No. 97-2

MerCruiser MCM/MIE Inline Diesel Heat Exchanger End Cover Torque

- a - Heat Exchanger
- b - Cast End Cover
- c - Stamped End Plate
- d - Engine Oil Cooler End Plate

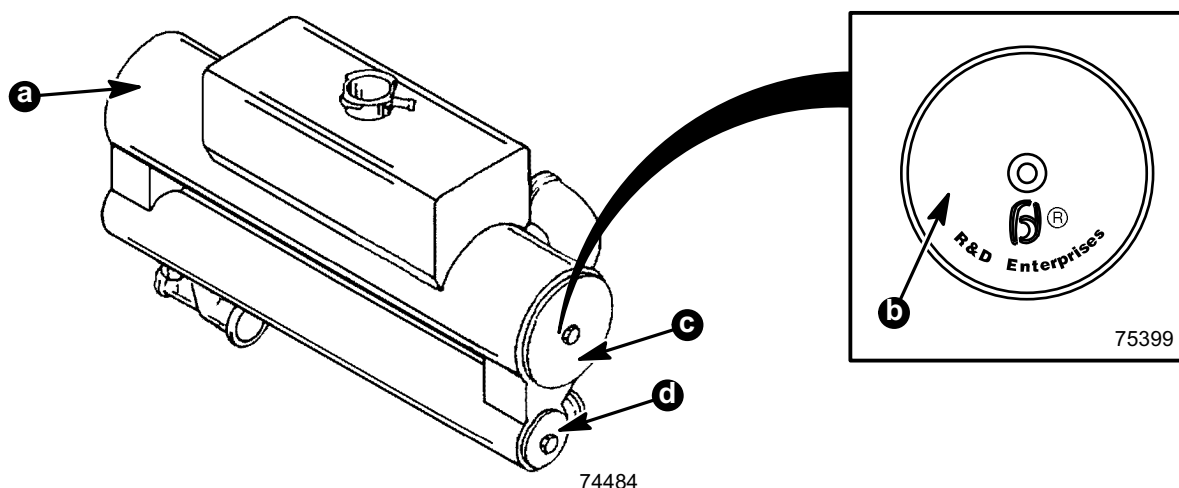
The Heat Exchanger has changed to a **P/N 807261** on the above model engines. This change includes new cast end covers on the main tank, which can be identified by the "R&D Enterprises ©" cast into the end cover. This cast cover uses a lower torque rating than previously required on the stamped end plates that were used on the heat exchanger main tank, **P/N 806830T**. The torque specification for both heat exchangers are as follows:

IMPORTANT: This new heat exchanger P/N 807261 will not backfit on engines below the serial numbers listed above.

DESCRIPTION			TORQUE		
Part Number	Heat Exchanger	Cover/Plate Location	Lb. In.	Lb. Ft.	N·m
807261	New-Style, Cast End Covers	Main Tank (Upper)	120-132		14-15
		Engine Oil Cooler (Lower)	108-120		12-14
806830T	Previous-Style, Stamped End Plates	Main Tank (Upper)		16	22
		Engine Oil Cooler (Lower)	108-120		12-14
